Re: Application to Revise Large Mining Operation Permit, Holnam, Inc. Devil's Slide Mine, M/029/001, Morgan County Utah

**RE: DOGM Questions and Review of Application to Revise Large Mining Operations/Permit
Overburden Dump, Devil's Slide Mine, M/029/001
Devil's Slide Plant - Morgan County, Utah**

Project: DUMP EXPANSION DRAINAGE AREAS HOLNAM DEVIL'S SLIDE MINE DEVIL'S SLIDE, UTAH MAP R647-4-111.2a			
Drawn:	SJE	Horiz. Scale: 1"=1000'	Vert. Scale: 1"=1000'
Checked:	MGR	Proj. No.: 50963	REV.
SHEET NO. _____		1 OF 1

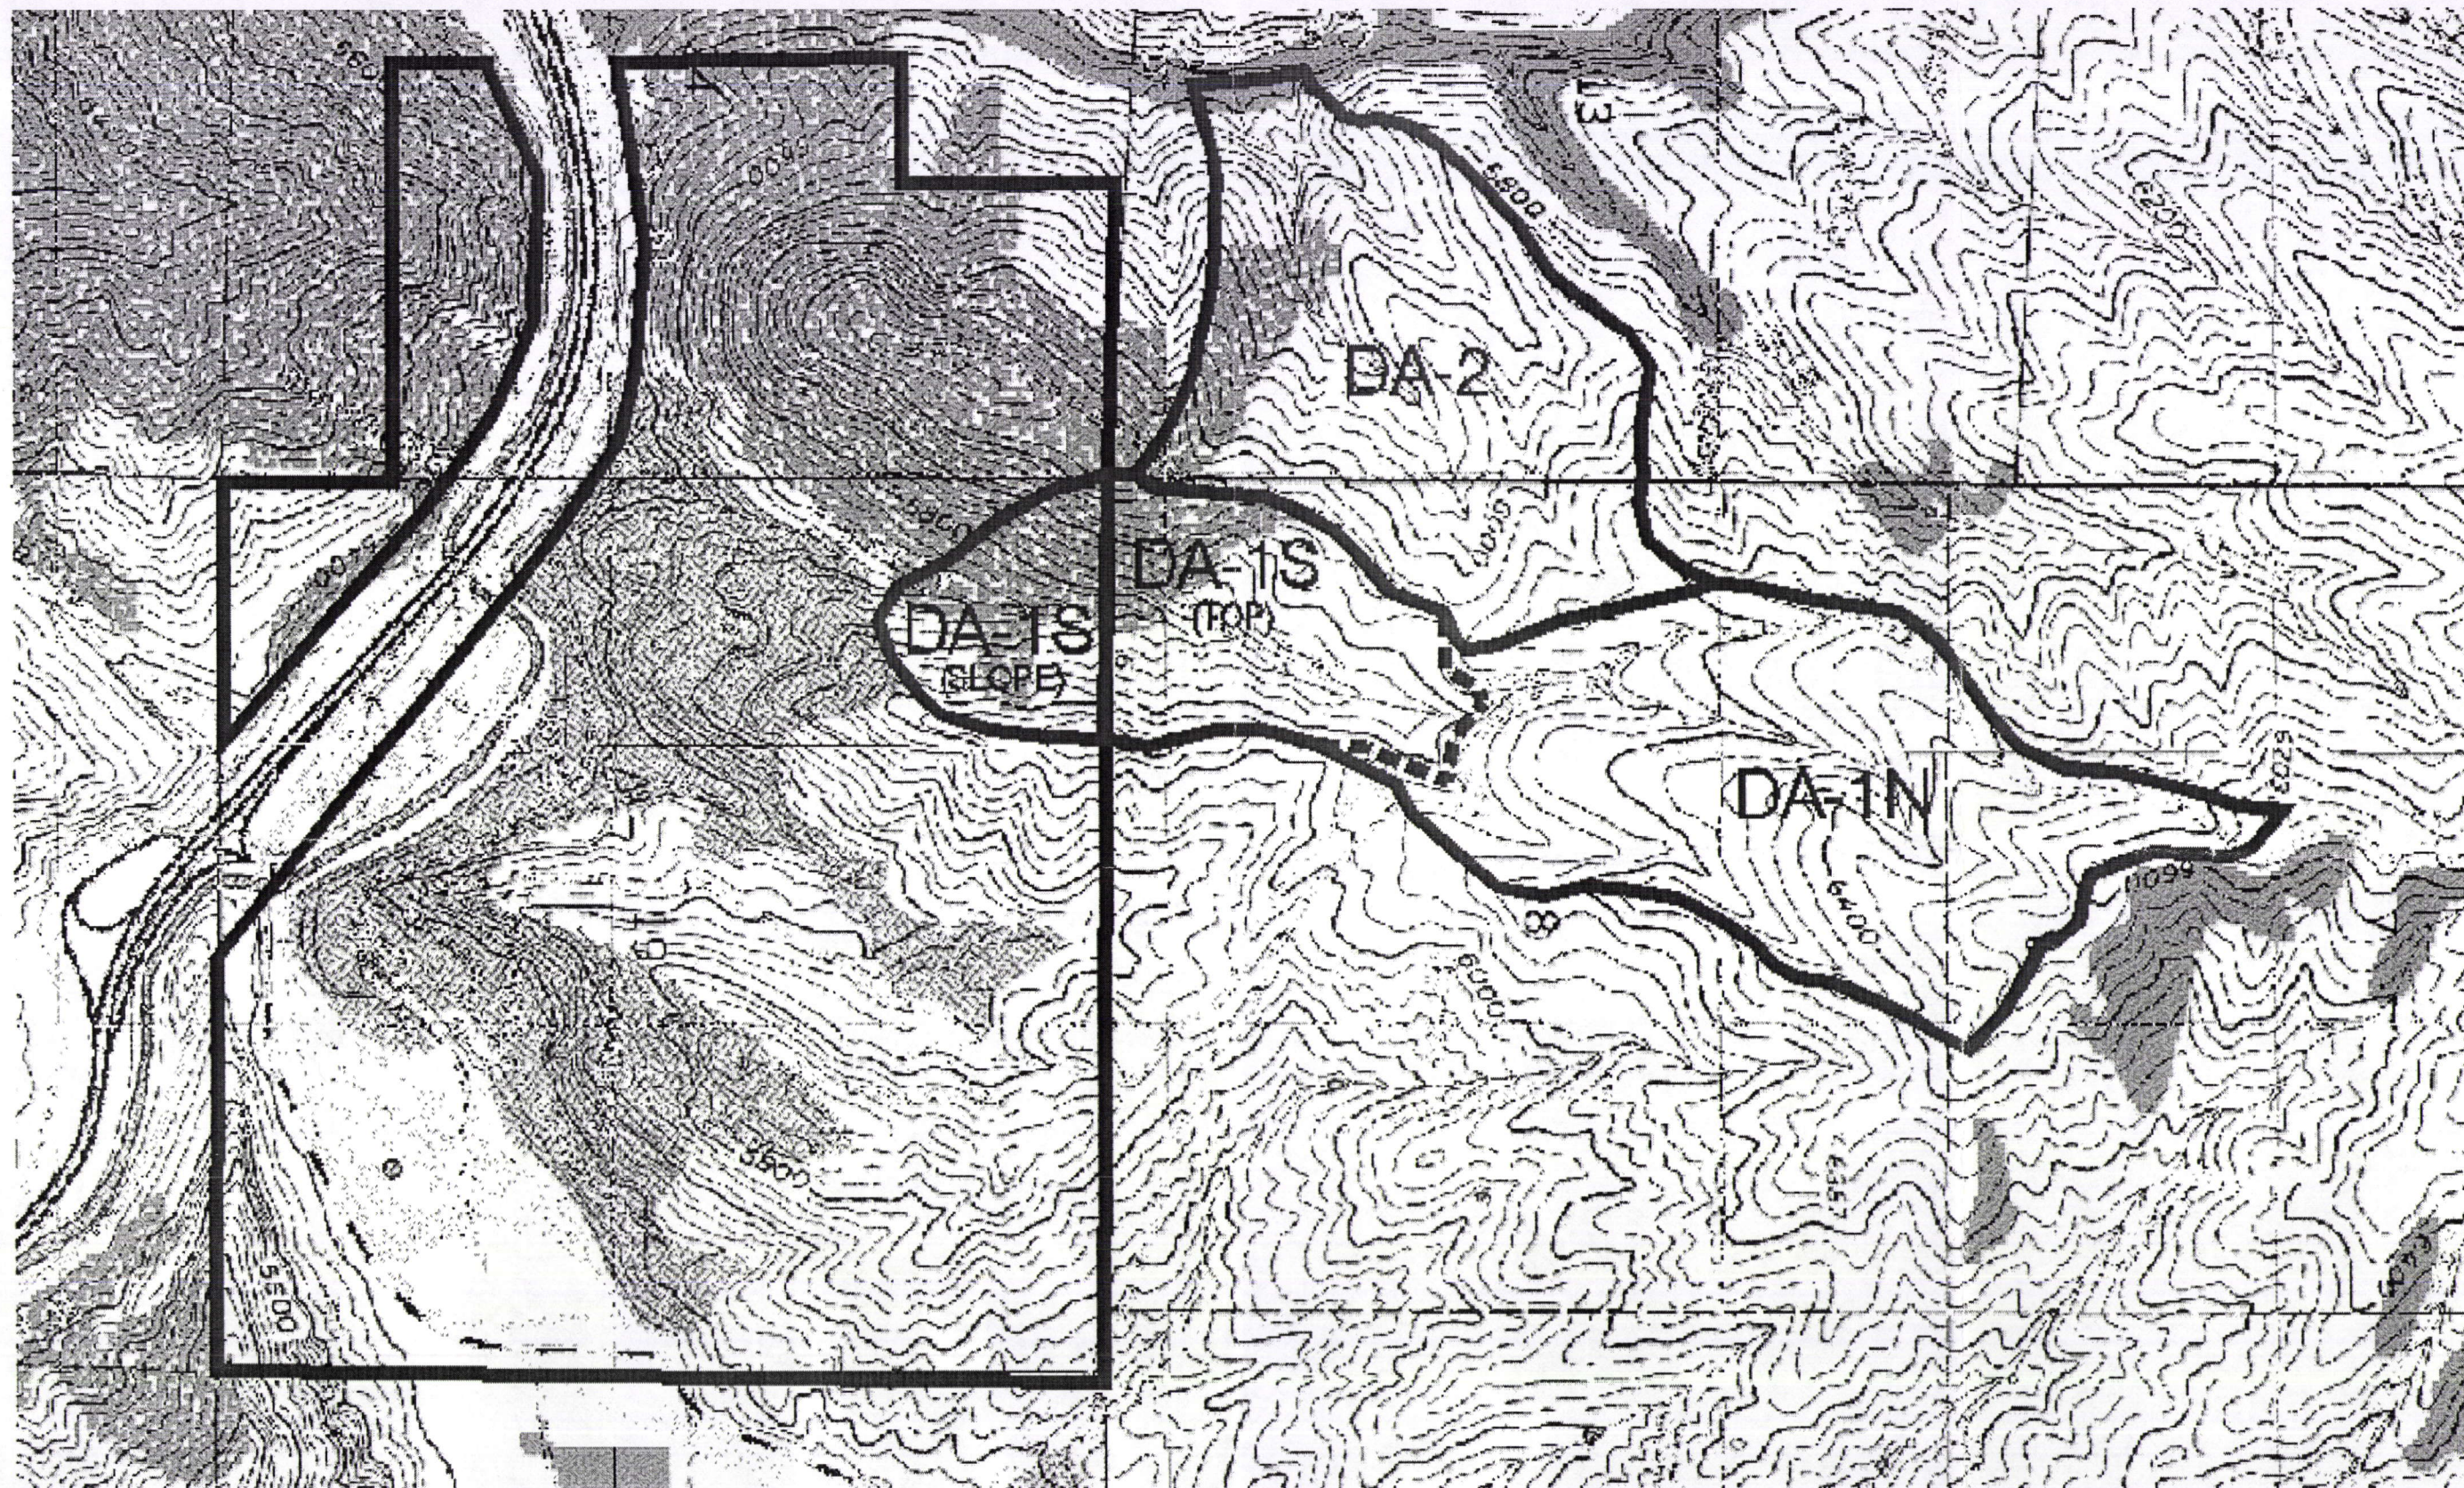
DOGM: *Nothing has been provided in the plans regarding location and sizing of reclaimed channels other than a statement that the drainage will be routed off the dump face. Please provide the necessary detail to describe how drainage will be routed off the dump face, i.e. location of channel and sizing of the channel handle the expected flows. This detail should provide an estimate of the watershed area contributing to this reclaimed drainage.*

A drainage area delineation of the Holnam dump expansion at the Devil's Slide Mine in Utah was conducted using a USGS quadrangle map. Two small drainage basins were identified that affect the proposed dump expansion (Drainage Area Map R647-4-111.2a under Appendix C). Existing plans call for a sloped fill area at the northeastern perimeter of the dump expansion that will create a desilting basin. As a result, and because of the different cover and slopes between the non-disturbed upper drainage area and the dump, the eastern drainage area was split into two sub-drainages for design purposes. They are DA-1N (northern section with native slopes and vegetation) and DA-1S (mine dump expansion).
